**Dendrobium – Area 3A – Longwall 19A – Subsidence Management Plan  
Addendum to Report No. MSEC1234 (Rev. B)**

## Addendum to Groundwater Assessment of Longwall 19A re: revised longwall geometry

<b>To:</b>	Cody Brady (Illawarra Metallurgical Coal)	cc:
<b>From:</b>	Stuart Brown	
<b>Subject:</b>	<b>Assessment of surface water flow and shallow groundwater effects of proposed Dendrobium Longwall 19A: Revised longwall geometry</b>	
<b>Date:</b>	20 February 2023	<b>Ref:</b> D23208

Figure 2-1

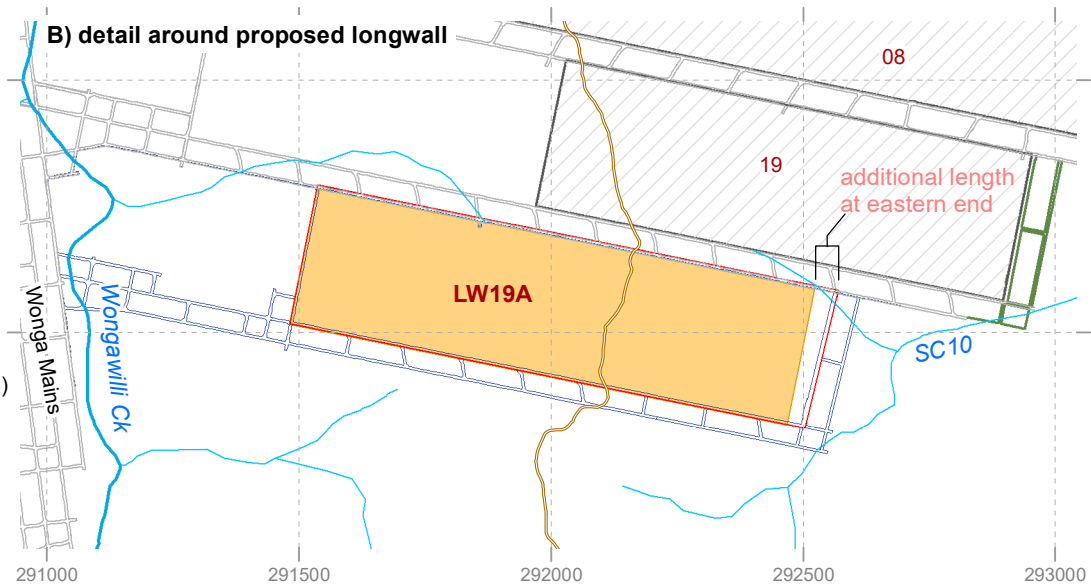
**Table 2-1** presents the revised longwall geometry (“revised layout”) for Longwall 19A in comparison to that reported and modelled previously. **Figure 2-1** presents both versions of the mine plan for comparison.

The revised layout for Longwall 19A is 41 m (+4%) longer than previously reported and modelled.

**Figure 3-2** Depth of cover and geological structures mapped around Longwall 19A

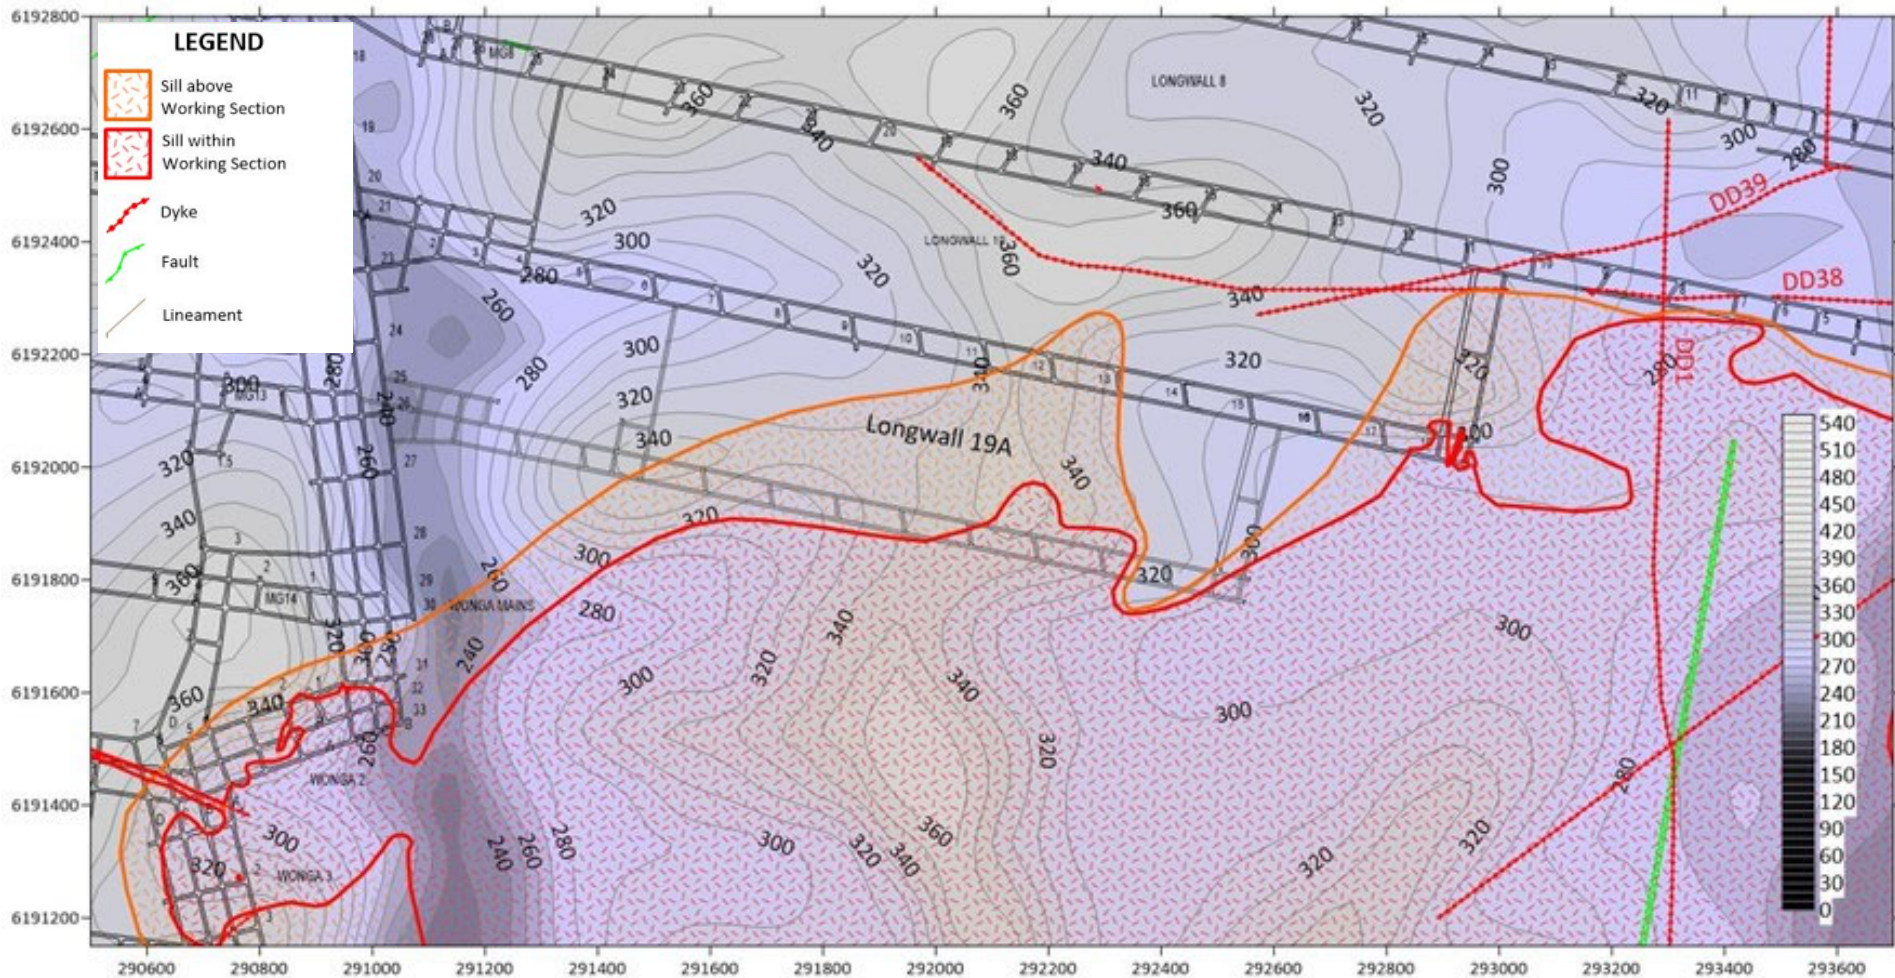
The incised valley at WC14 means that the lowest depth of cover (**Figure 3-2**) is at or beneath that valley. The revised layout is no different near WC14 as the previous layout. As such, the minimum depth of cover for this longwall is unchanged from that reported in the Longwall 19A Groundwater Assessment (Watershed HydroGeo, 2022b), although the minimum depth of cover at the eastern end would decline slightly (from 310 m to 305 m, approximately).

**Figure 3-2** displays the latest geological structure mapping from IMC geologists (Illawarra Metallurgical Coal, 2023), which incorporates recent knowledge and mapping around the current longwall block (Longwall 19).

However, the dykes that were encountered through much of Longwall 19, i.e. DD38 and DD39 (**Figure 3-2**), have been mapped as terminating or being orientated away from MG19 (the gate road between Longwalls 19 and 19A, and so are not considered relevant to Longwall 19A).

**Figure 3-3 Distance and risk of effects on adjacent reservoirs**

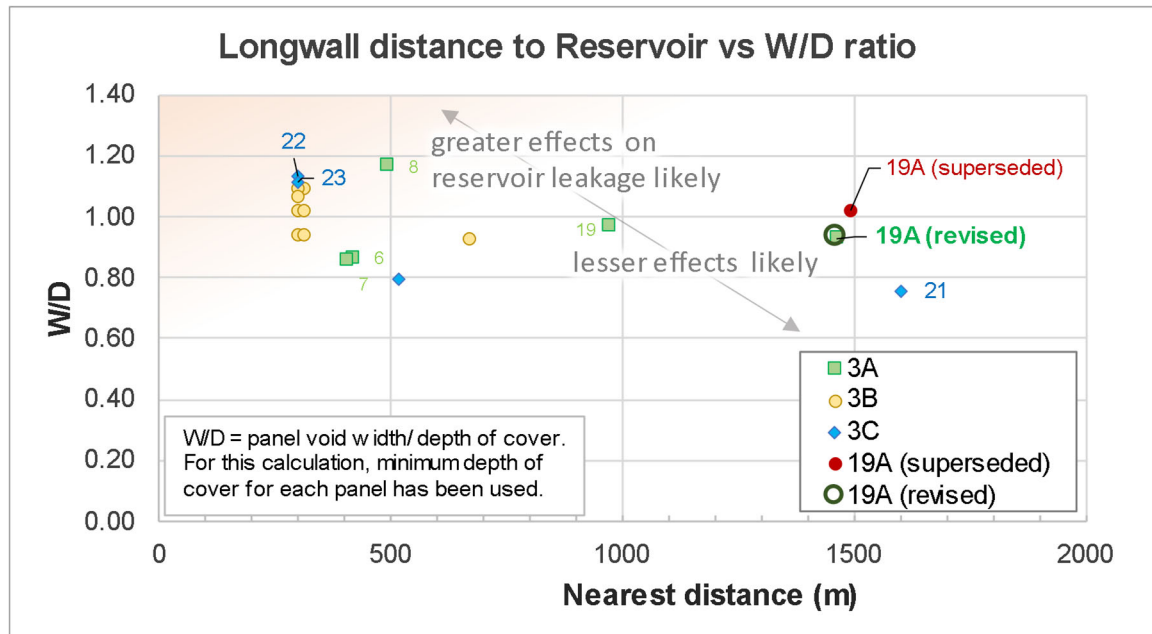
Groundwater drawdown around many longwalls at Dendrobium has or would cause reduced baseflow and/or result in leakage from water supply reservoirs. It is considered that leakage from Cordeaux Reservoir (or Avon) would not occur as a result of mining at Longwall 19A due to the distances involved, as indicated in **Figure 3-3**.

Despite the slight reduction in distance from this longwall to the reservoir (Section 3.1), we consider that the potential for this to occur has declined slightly with the change in modelled or assumed longwall geometry (specifically, due to void width).

**Figure 3-5 Distance and risk of effects on tributary SC10**

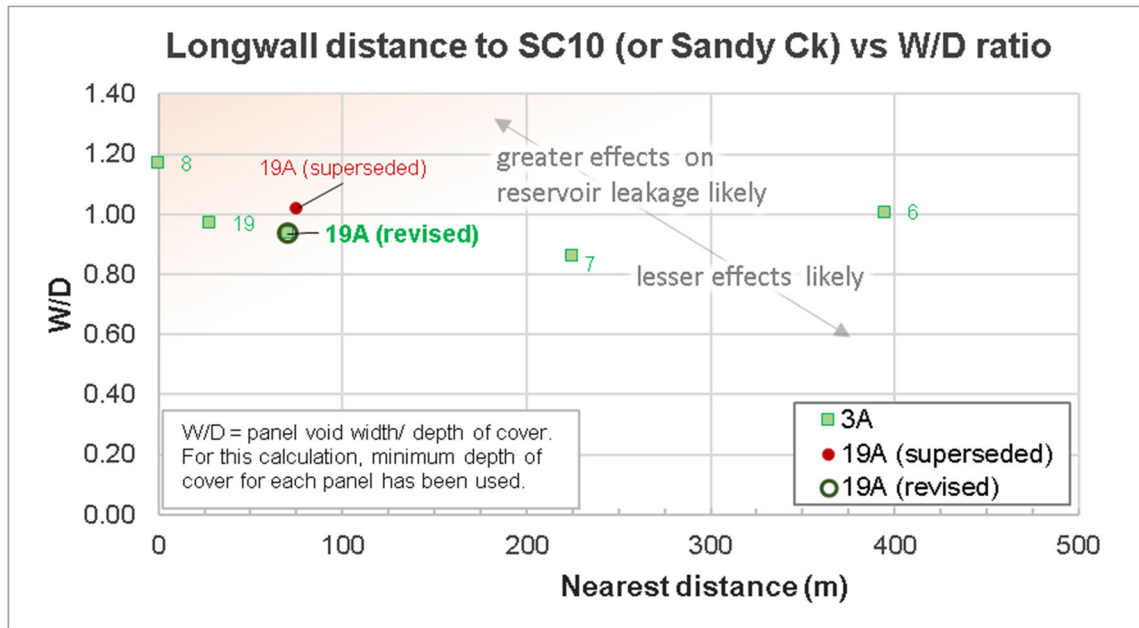
Figure 3-5 shows that Longwall 19A has a relatively higher risk of impacting SC10 than Longwalls 6 and 7, but lower than Longwall 8 and the current Longwall 19.

The revised layout will mean that Longwall 19A is slightly closer (which would increase the potential for surface cracking effects), but the revised void width is lower, which slightly reduces the risk or magnitude of impact related to the connected fracture zone (Section 3.3.4).

**Figure 3-6 Spatial variation in height of connected fracturing (HOCF) at Dendrobium**

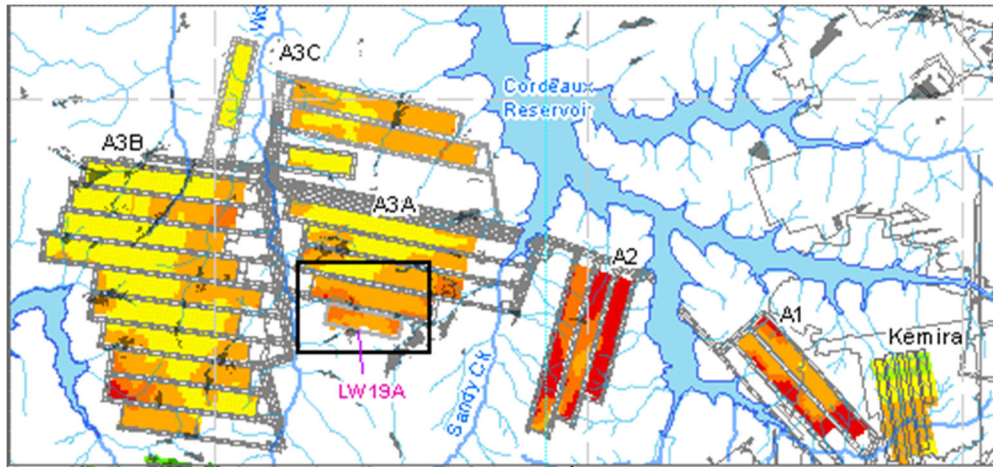
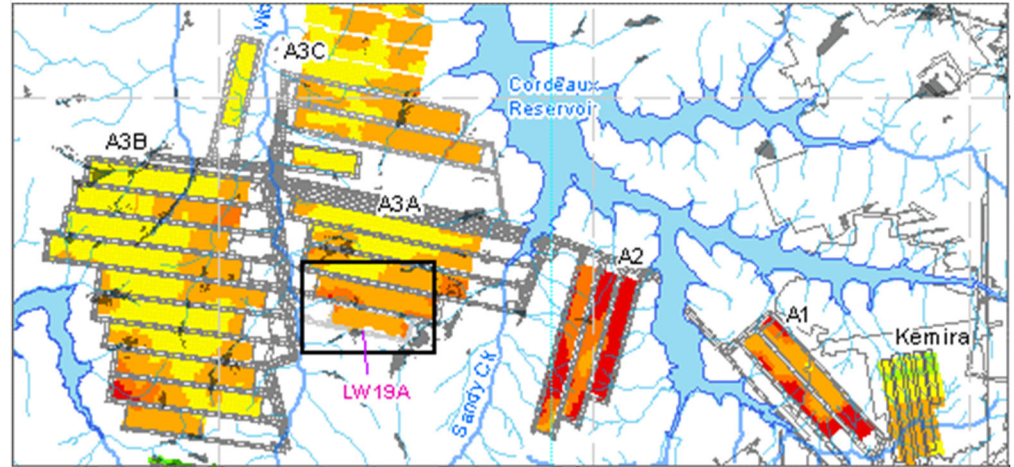
**Figure 3-6** presents this in terms of the vertical separation between the top of the zone and the base of the surface cracking zone (SCZ), for A) previously reported longwall geometry and B) the revised Longwall 19A geometry. This figure is presented at a scale appropriate for comparison with other parts of Dendrobium Mine.

- The slight eastern extension of Longwall 19A in the **Figure 3-6B** (revised layout) compared to **Figure 3-6A** (previous layout).
- The slight increase in the separation between the height of connected fracturing (HO�F) and SCZ in **Figure 3-6B** (paler orange) compared to **Figure 3-6A**. This is related to the reduction in modelled void width from 305 m to 281 m.

Figure 4-2 Modelled groundwater levels at S1888 (Longwall 19A footprint) – revised layout

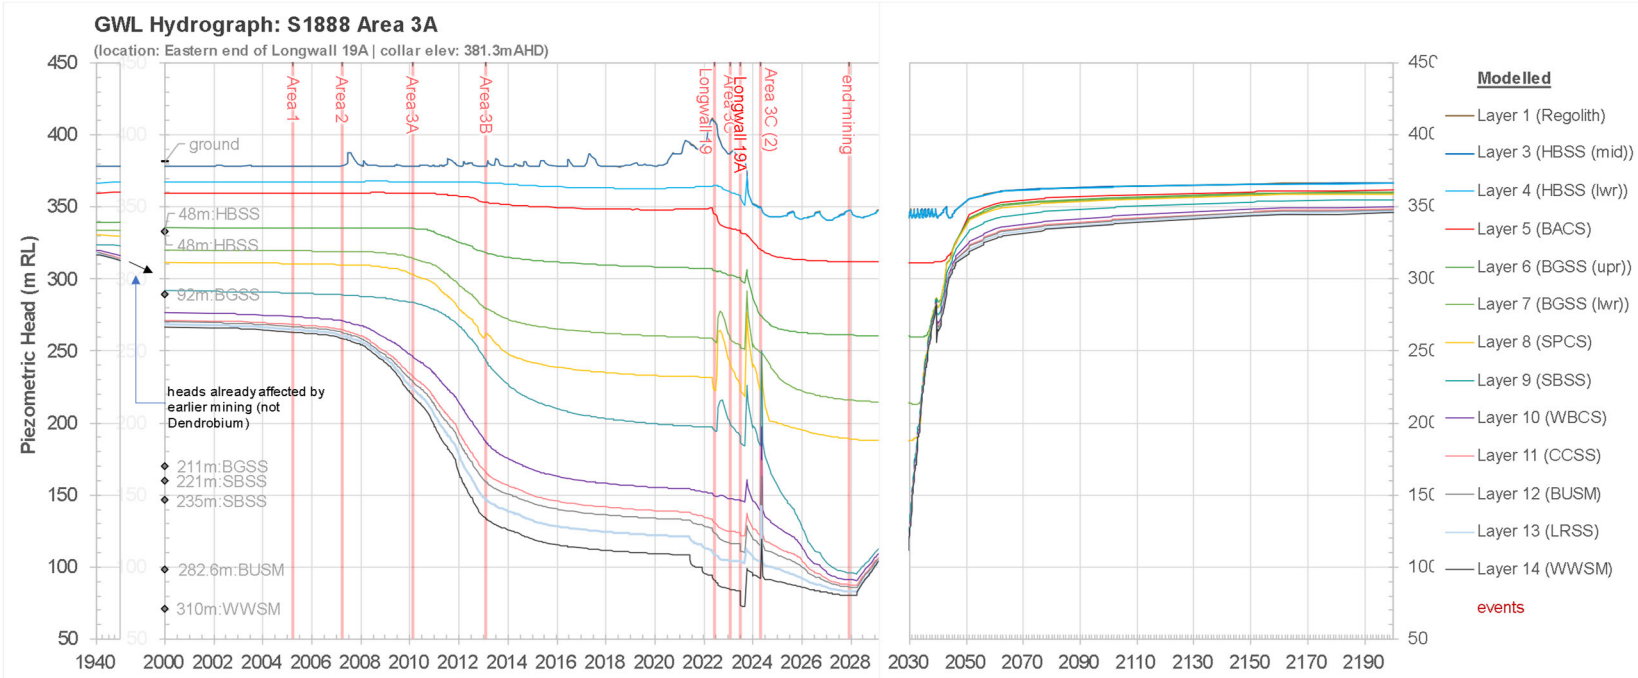
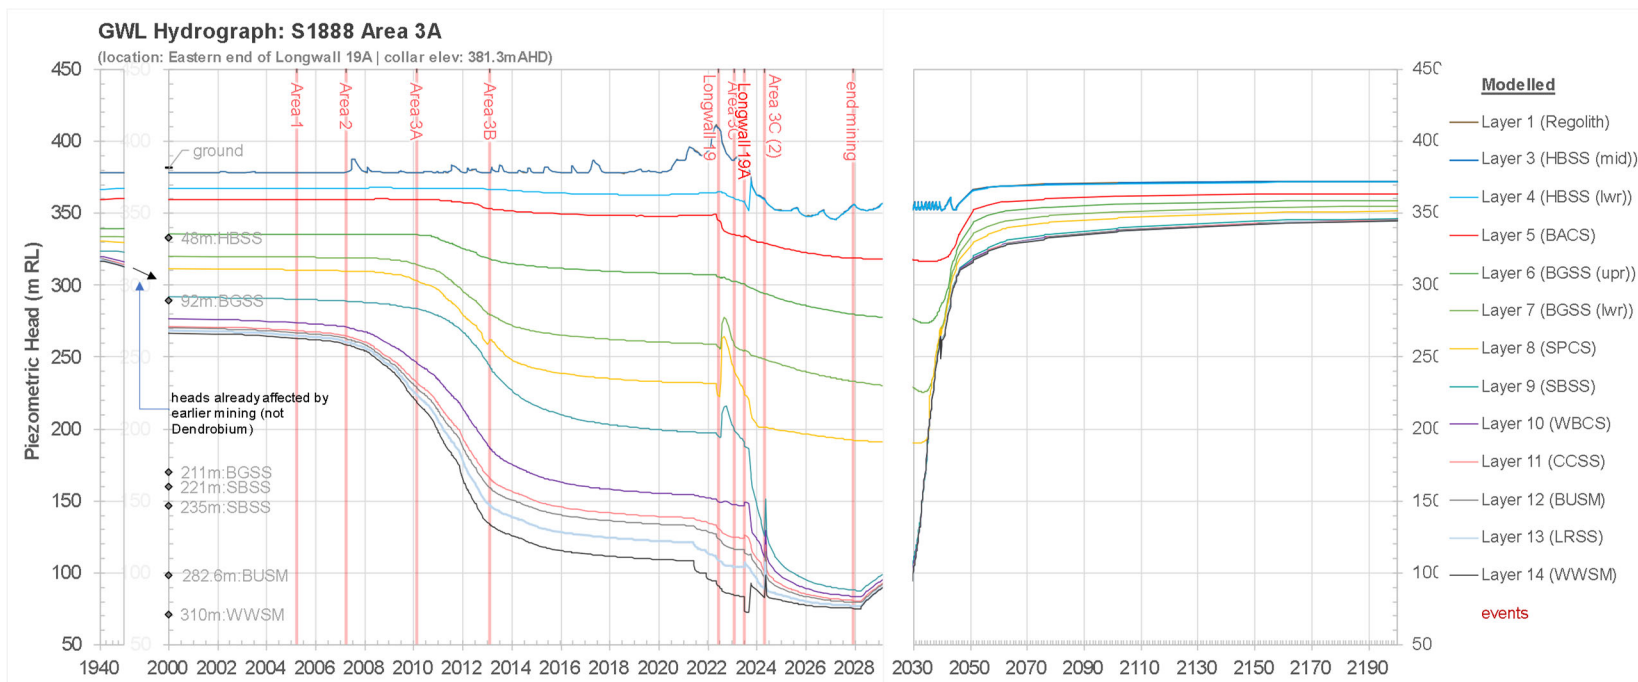
When comparing these modelled groundwater level hydrographs for site S1888 within the footprint (Figure 4-1 and Figure 4-2), there is essentially no difference between the simulated post-mining groundwater levels and drawdown in the deeper units; Bald Hill Claystone (BACS) down to the Wongawilli Seam (WWSM). This is because, despite the change in void width, the connected fracturing would still result in significant depressurisation and even some horizons of zero or near-zero groundwater pressure.

The main difference is in the lower Hawkesbury Sandstone (HBSS lwr). The assessment of the previous layout (Figure 4-1) indicated drawdown from 367 mAHD down to 340 mAHD, i.e. 27 m drawdown, before recovering to 1 m below pre-mining levels (366 mAHD).

For the revised layout (Figure 4-2), groundwater levels in the HBSS-lwr are predicted to decline to 345 mAHD (i.e. 22 m drawdown), before recovering to 371 mAHD, i.e. above pre-mining levels.

Figure 4-4 Modelled groundwater levels adjacent to Wongawilli Creek – revised layout

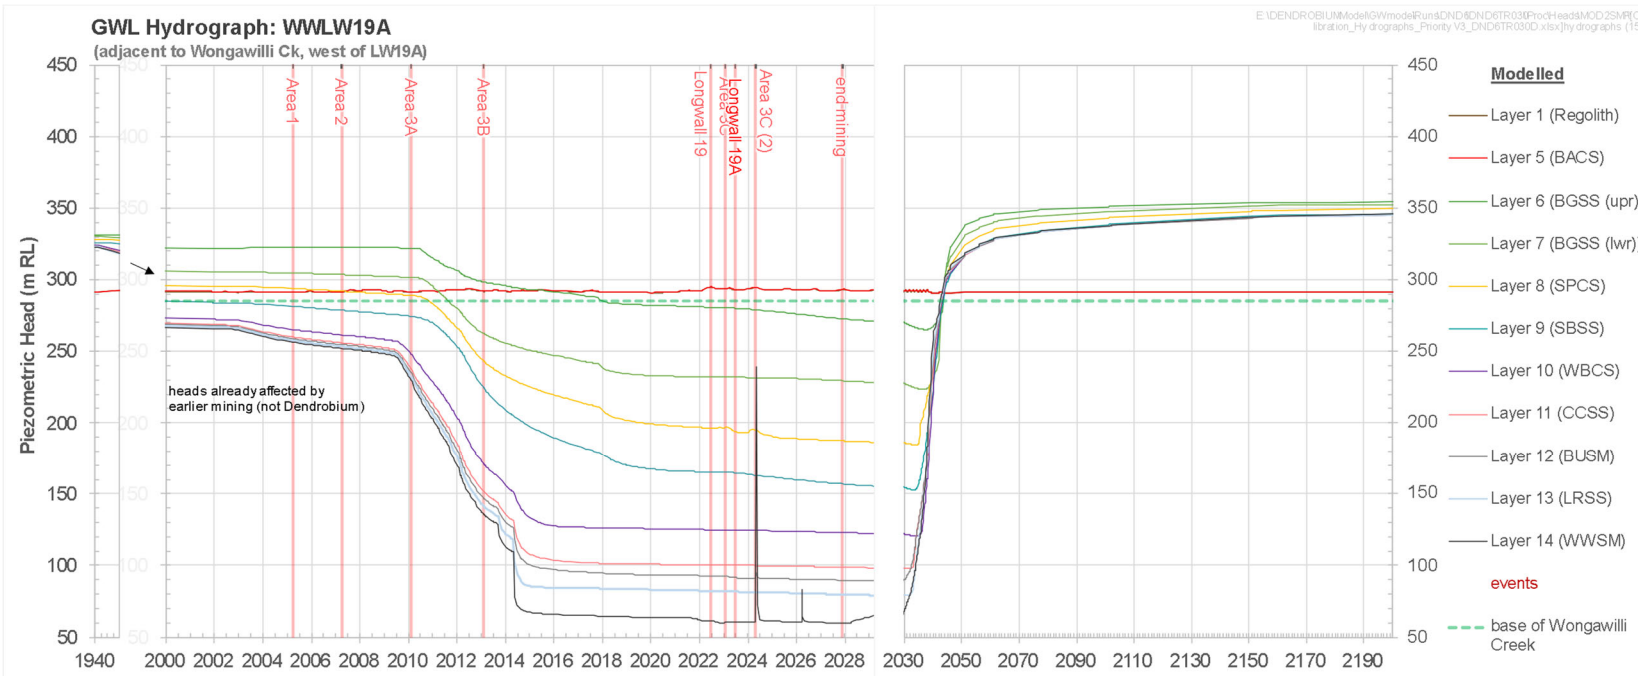
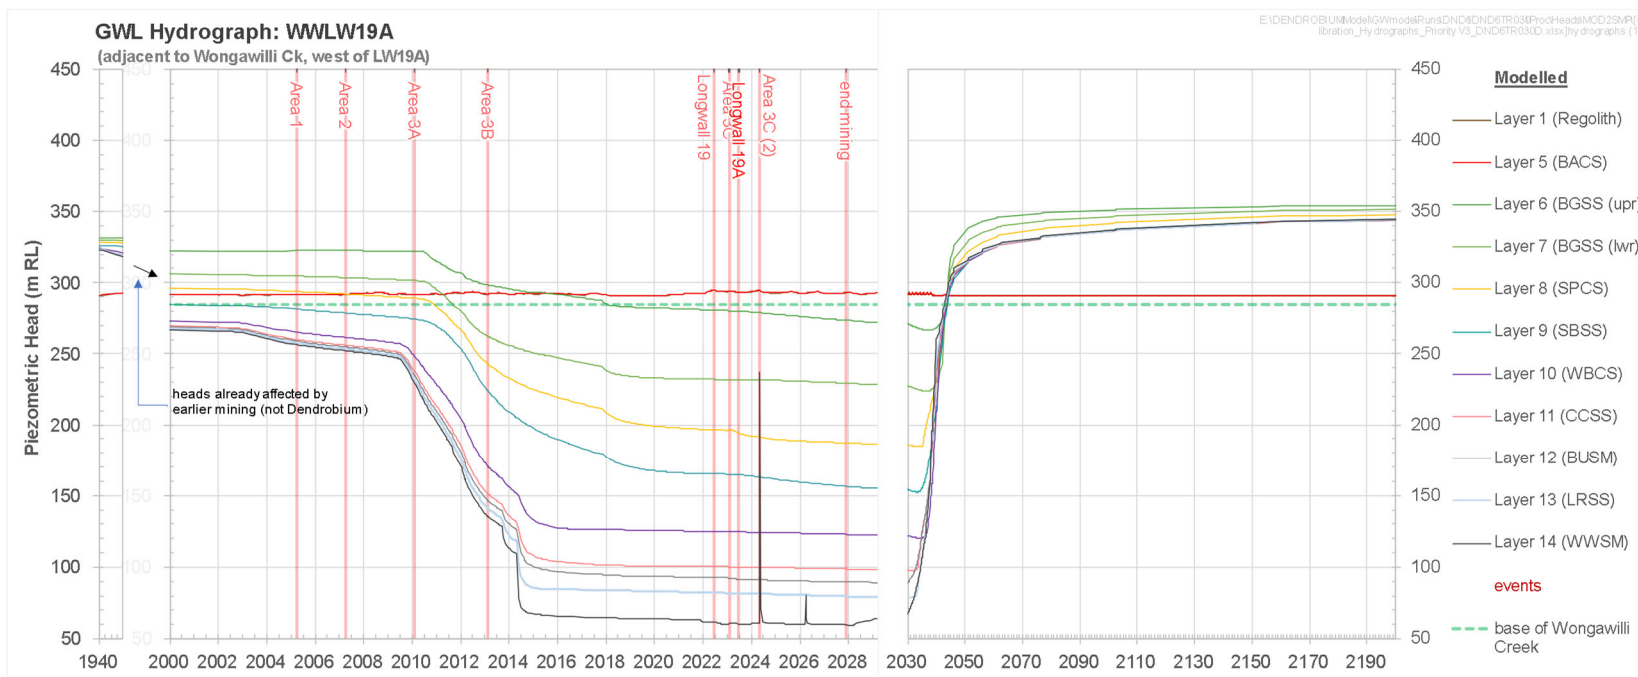
When comparing these modelled groundwater level hydrographs for this site adjacent to Wongawilli Creek (**Figure 4-3** and **Figure 4-4**), there is essentially no difference between the simulated post-mining groundwater levels and drawdown in the deeper units; lower Bulgo Sandstone (BGSS-lwr) down to the Wongawilli Seam (WWSM). This is because, despite the change in void width, the connected fracturing would still result in significant depressurisation and even some horizons of zero or near-zero groundwater pressure.

The main difference, and even this is very minor, is in the upper Bulgo Sandstone (BGSS upr). The assessment of the previous layout (**Figure 4-3**) indicated drawdown from 322 mAHD down to 265 mAHD, i.e. 57 m drawdown, before recovering to 31 m above pre-mining levels (353 mAHD).

For the revised layout (**Figure 4-4**), groundwater levels in the HBSS-lwr are predicted to decline to 266 mAHD (i.e. 56 m drawdown), before recovering to the same level as in the previous assessment (353 mAHD), i.e. also above pre-mining levels.
